File No. F-01-122
Willetts Property

DEPARTMENT OF PLANNING AND ZONING FINAL PLAT ORIGINAL FOR SIGNATURE APPROVAL

RE: Septic System Abandonment
Percolation Application #510157
Property ID: Wilet Property -
Long Corner Road
Tax Map: 6 Block: 21 Parcel: 55

RE: Percolation Test Results
Application # A510157
Willetts Property
Long Corner Road
Proposed use: Subdivision

F-01-122
2/27/01
Revised Final
Driveway Easement
Changes

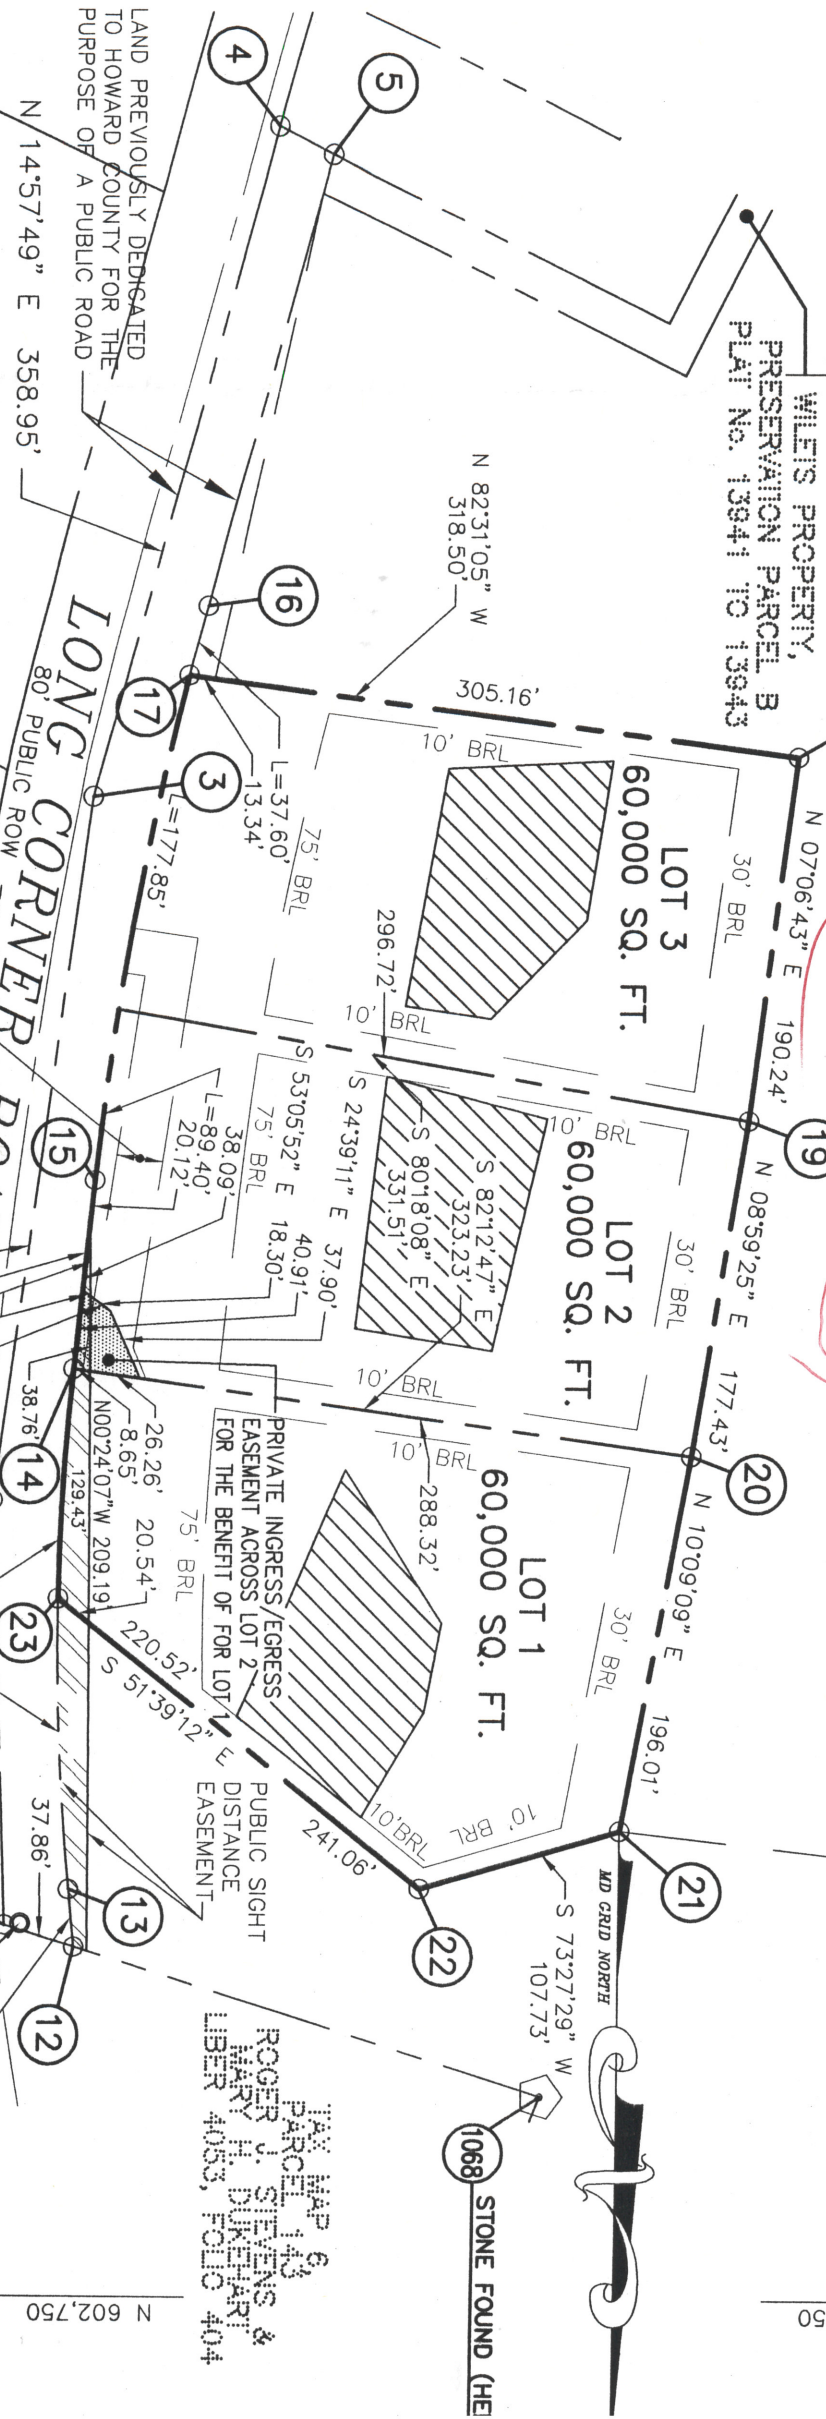
EX. 24' USE-IN-COMMON
DRIVEWAY EASEMENT FOR
LOTS 1 THRU 3 TO BE
ABANDONED BY THIS PLAT

SITE INSPECTION SHEET

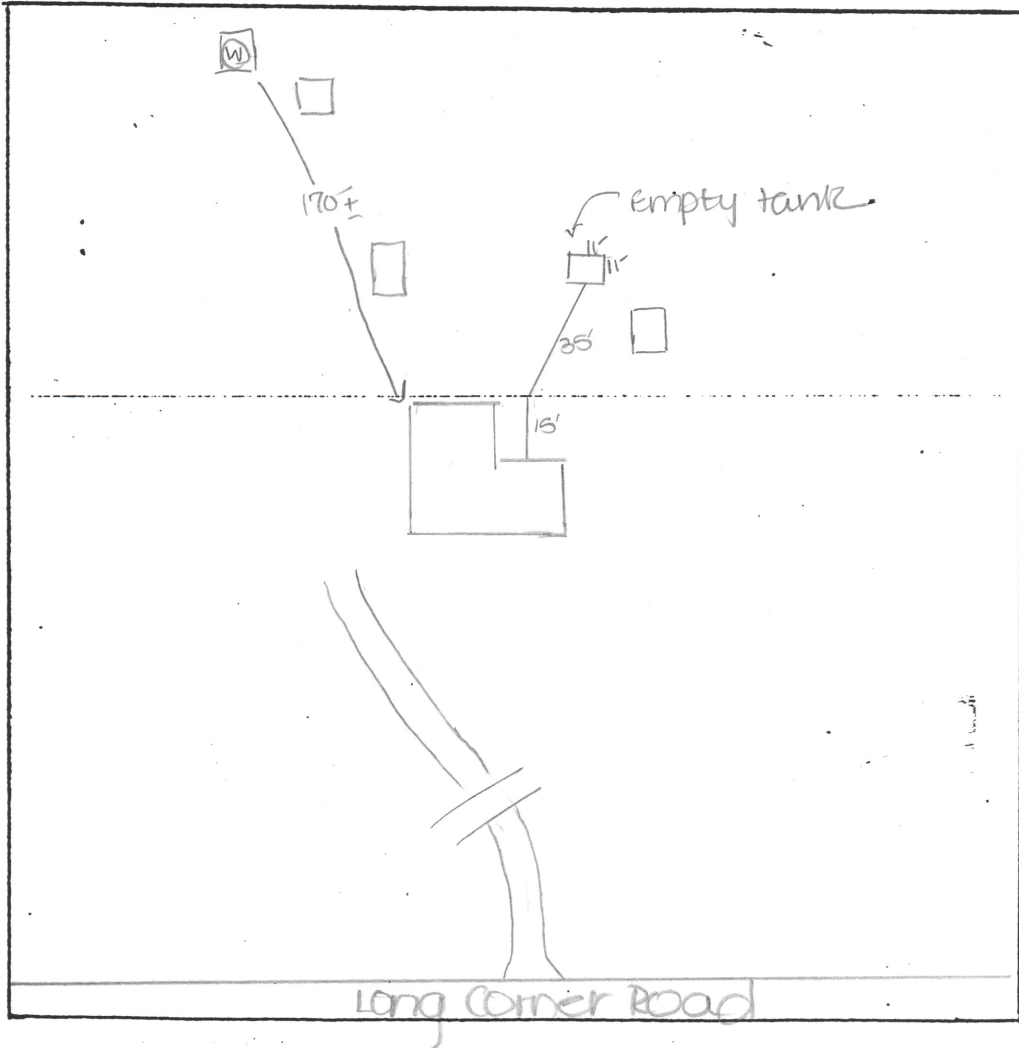
PROPOSAL: Abandonment of existing septic system

COMMENTS: drilled well in pit/ small well house previously abandoned
Terra cotta sewer line exiting house cut at house -
6' deep, 11' square cinder block tank empty - filled w/
clean fill. No outlet pipe.

SITE INSPECTION SHEET

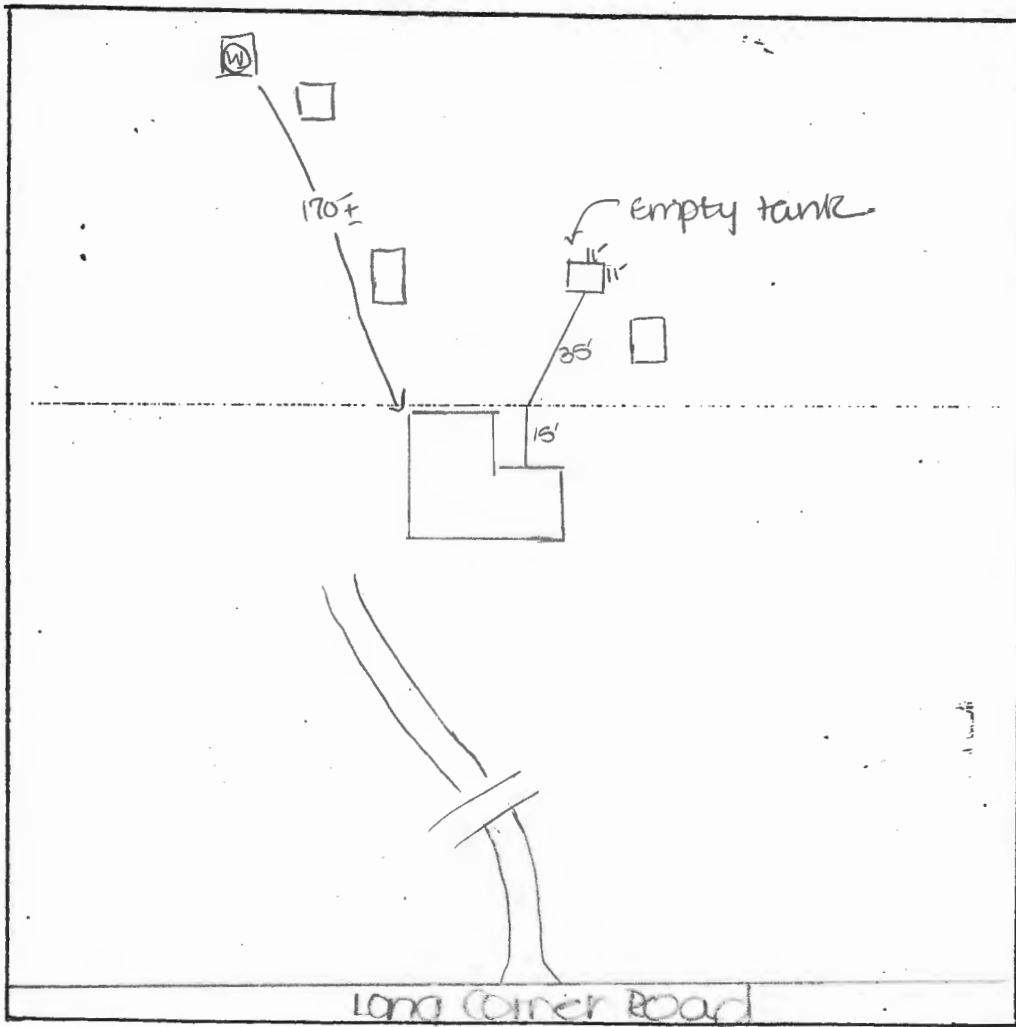
PROPOSAL: Abandonment of existing septic system

COMMENTS: Drilled well in pit/ small well house previously abandoned.
Terra cotta sewer line exiting house cut at house -
6' deep, 11' square cinder block tank empty - filled w/
clean fill. No outlet pipe.
